# Rong Rui Garments BD Ltd

24 April 2024

## 2. Observations

Loading condition

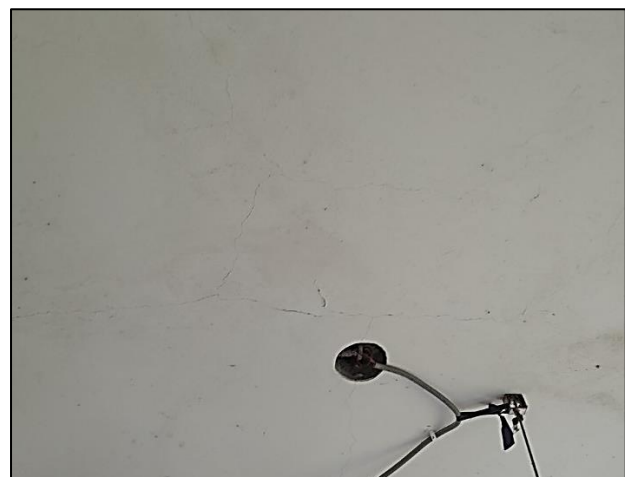
**Observation-1:** Stress in the columns exceeds the normal design limit. [Building-1 (Production Building)]

**Description:** Cursory calculation indicates that stress in the column exceeds the normal design limit considering 3 kPa live load for the typical floor, 5 kPa for stairs, 1.5 kPa for the roof, and minimum concrete strength based on aggregate type.

Structural drawings, foundation information, and floor live load plans were not found on-site during the inspection.

A Detail Engineering Assessment (DEA) report was found on site where core test value was considered for this structure, but no test report was found.

The building engineer is required to prepare a complete DEA report based on in-situ material test report, updated as-built drawings, and live load plan.

Shed:2 (Generator and sub-station)

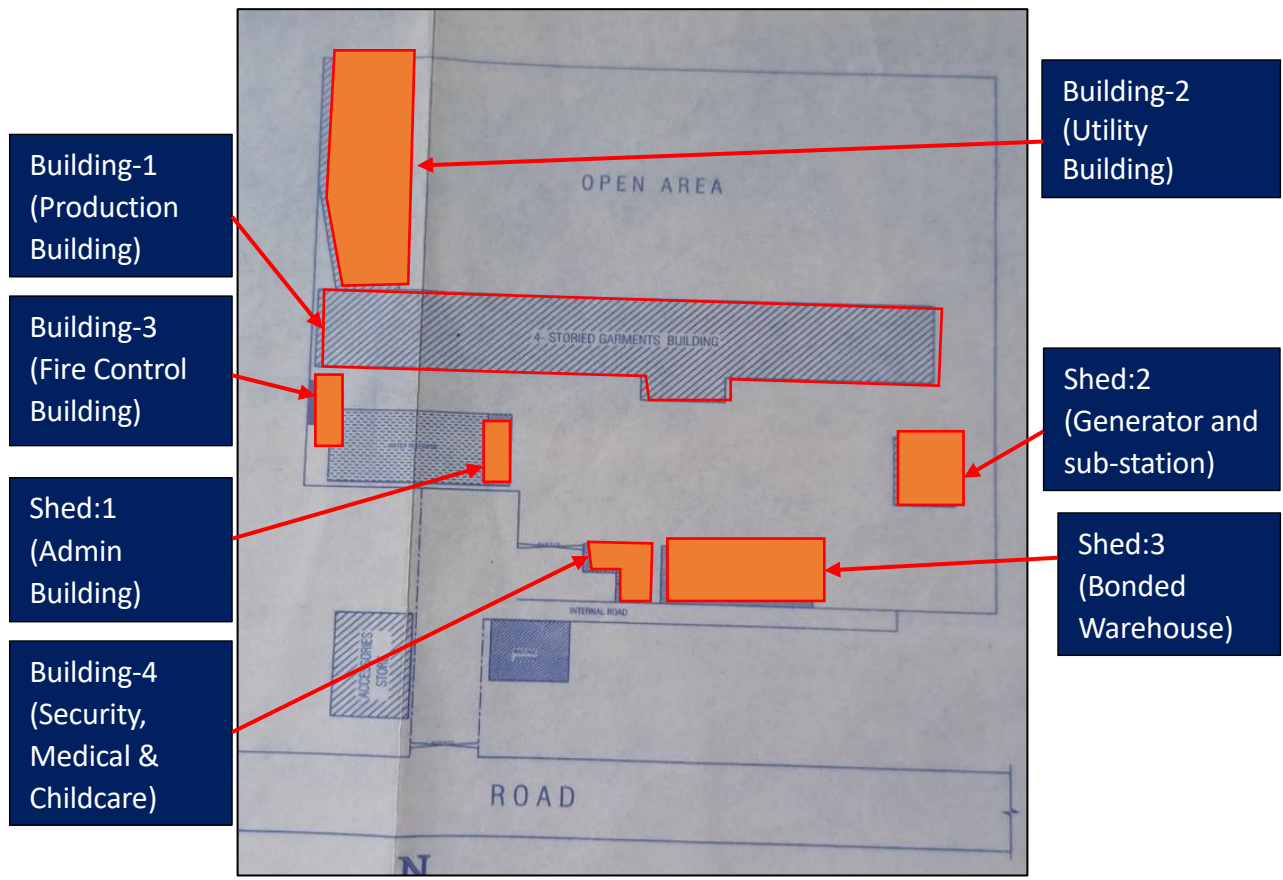
**Observation-10:** Lack of lateral stability. Shed:1 (Admin Building), Shed:2 (Generator and sub-station), Shed:3 (Bonded Warehouse))

**Description:** A lack of lateral load transfer media was observed in the structures. Also, no as-built structural drawings were available for the structures.

The building engineer is required to carry out an Engineering Assessment (EA) to check the lateral stability and adequacy of all structural elements of the structure based on in-situ material strength and software-based analysis which shall be prepared in compliance with section 1.9.1, part-6 of BNBC.
